**Check Engine MIL - DTC P0121 Flagged –
Connector Material Mismatch –
AJ27 Engines – Modify Harness**

MODEL
1999-2001 MY XK Range
1999-2001 MY V8 XJ Series
VIN
031303-A22860
853936-F40117

ILLUSTRATION 1

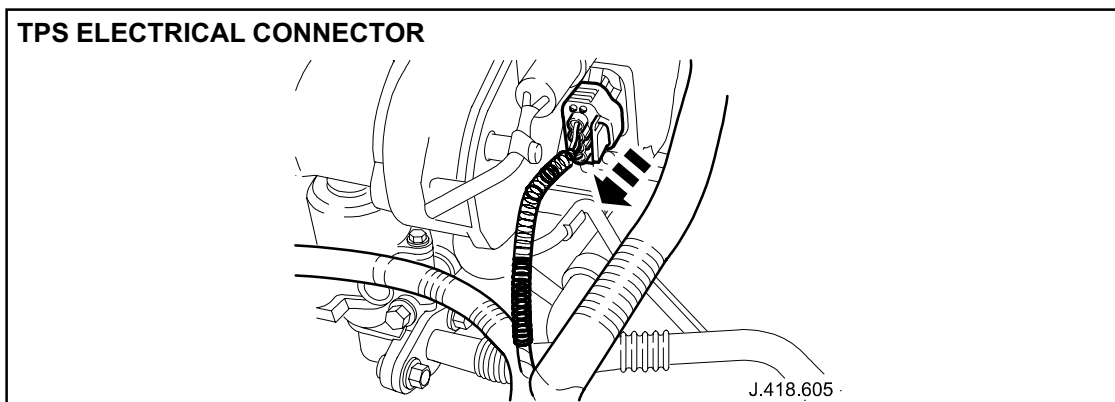
- Remove left and right hand bulkhead covers.
 - Remove engine compartment rear cover.
 - Remove nut securing engine harness main electrical connector to support bracket.
 - Reposition main electrical connector upwards.
4. On all vehicles, disconnect TPS electrical connector (Illustration 1).

ILLUSTRATION 2

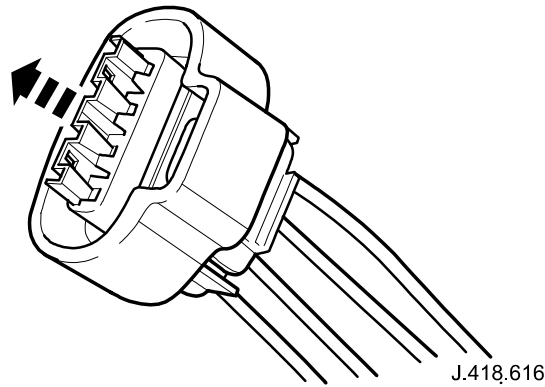
5. Reposition TPS electrical connector upwards for access.
6. Remove tape from convoluted sleeve.
7. Remove and discard convoluted sleeve from wiring harness.
8. Remove electrical tape from wiring harness.
9. Note position of wires in TPS electrical connector.
10. Displace and remove anti-back-out device from TPS electrical connector (Illustration 2).

ILLUSTRATION 3

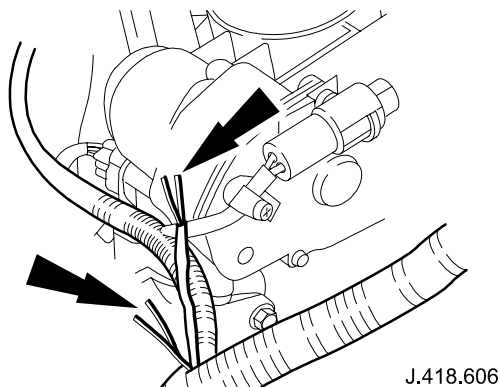
11. Remove the existing tin-plated terminals from the TPS electrical connector.
12. Cut and remove existing tin-plated electrical terminals/wires (Illustration 3).

Note: Make sure to stagger the cuts to allow installation of the convoluted sleeve after modification.

ILLUSTRATION 4

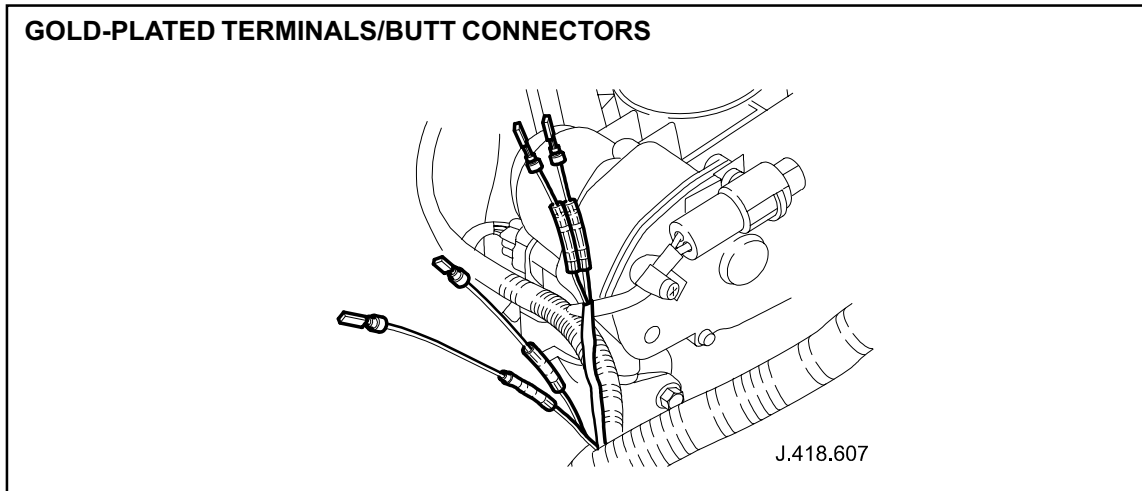
17. Secure butt-splice connectors/terminated cables to existing wires (Illustration 4).

ILLUSTRATION 5

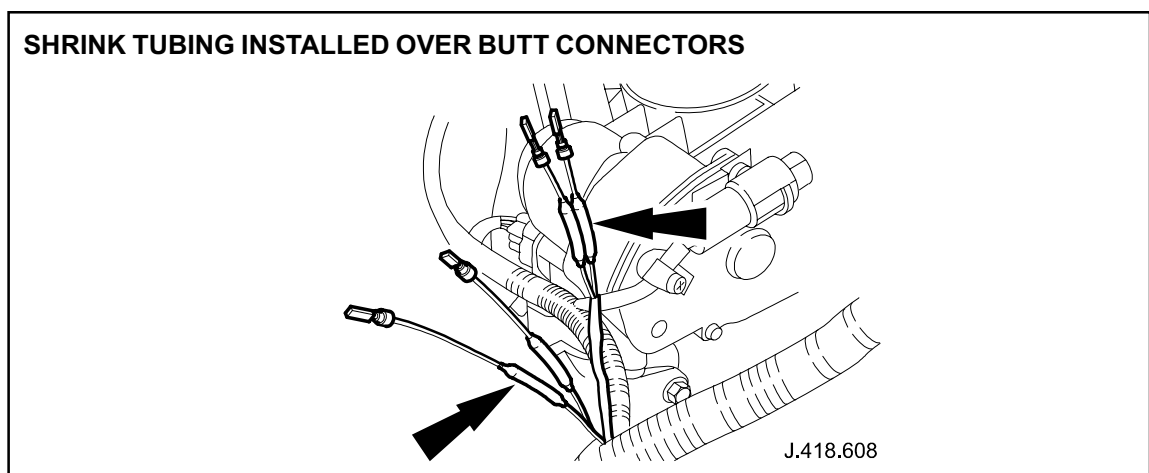
18. In turn, install heat-shrink tubing from harness repair kit over butt-splice connectors, using suitable heat source (Illustration 5).

ILLUSTRATION 6

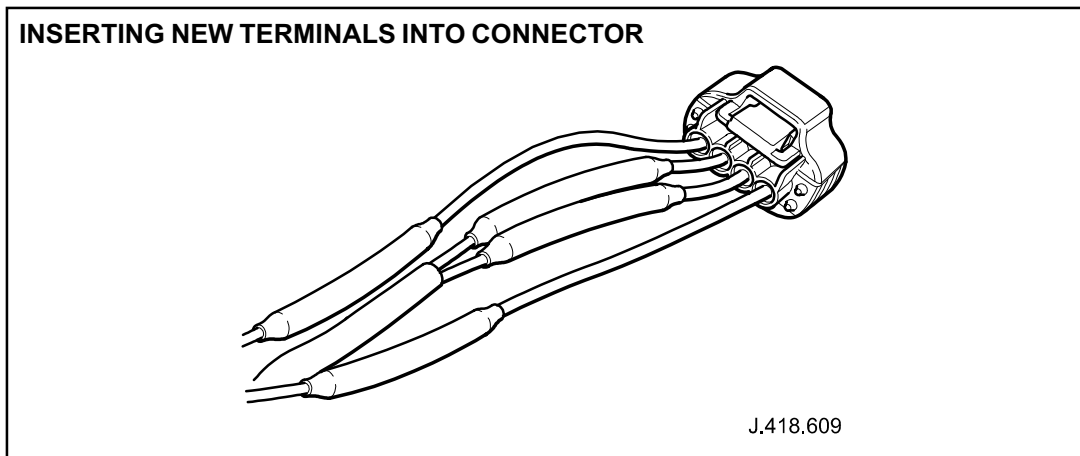
19. Install gold plated electrical terminals (into positions noted at step 9) into TPS electrical connector (Illustration 6).

ILLUSTRATION 7

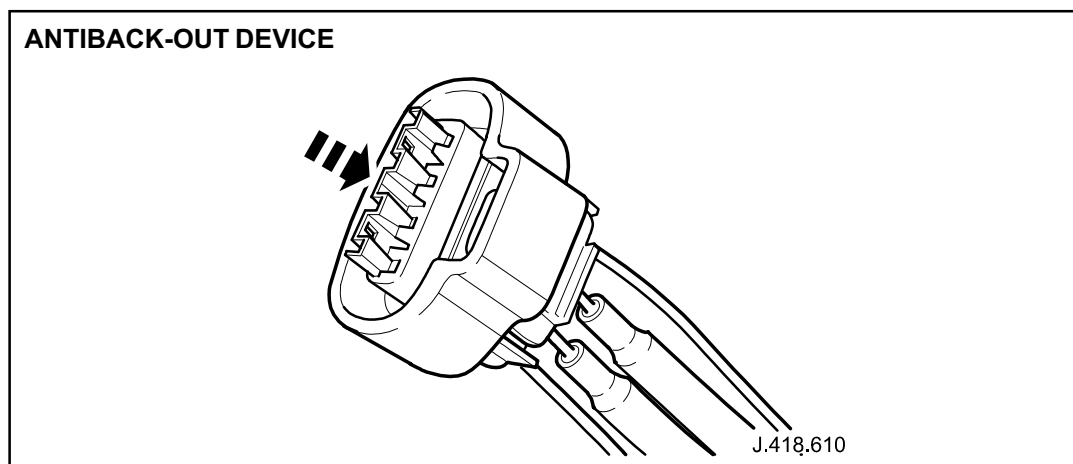
20. Install anti-back-out device to TPS electrical connector (Illustration 7).

ILLUSTRATION 8

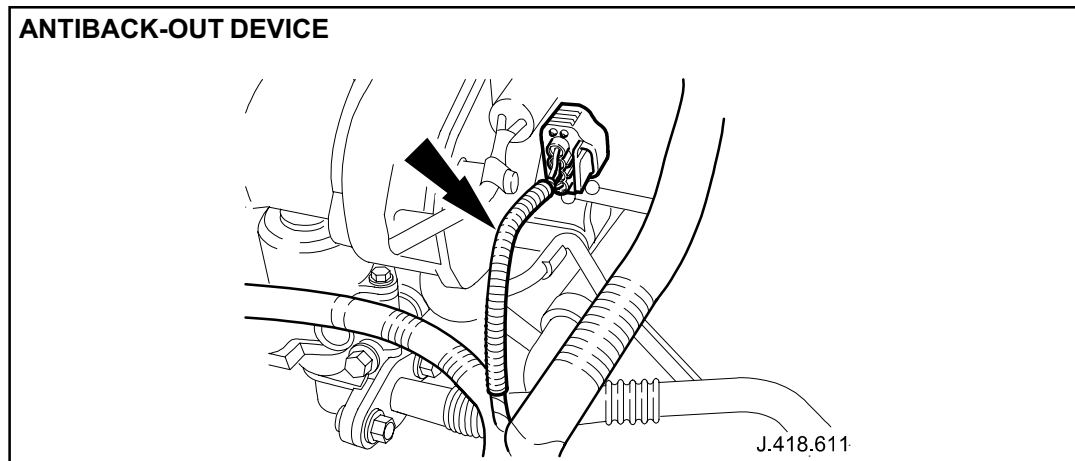
21. Install new convoluted sleeve around TPS wiring harness and secure using suitable electrical tape (Illustration 8).

ILLUSTRATION 9

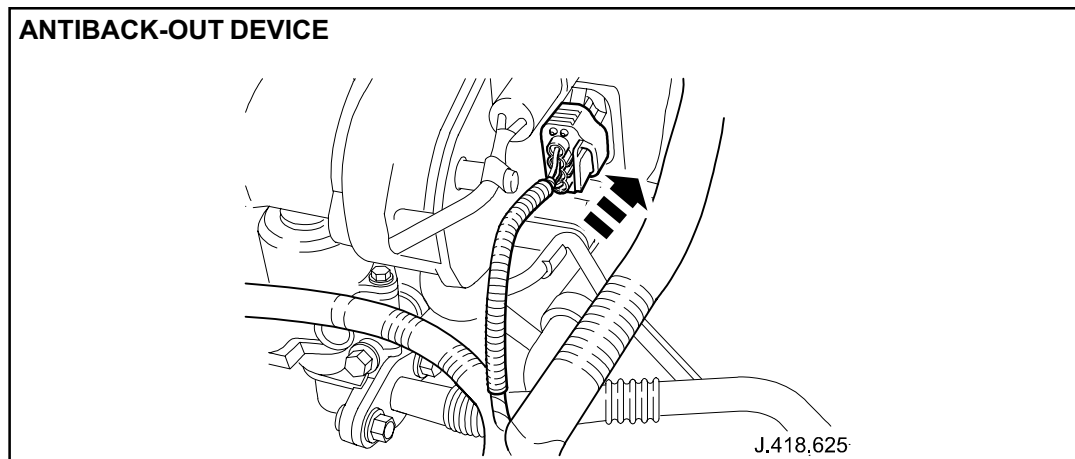
22. Install TPS electrical connector (Illustration 9).
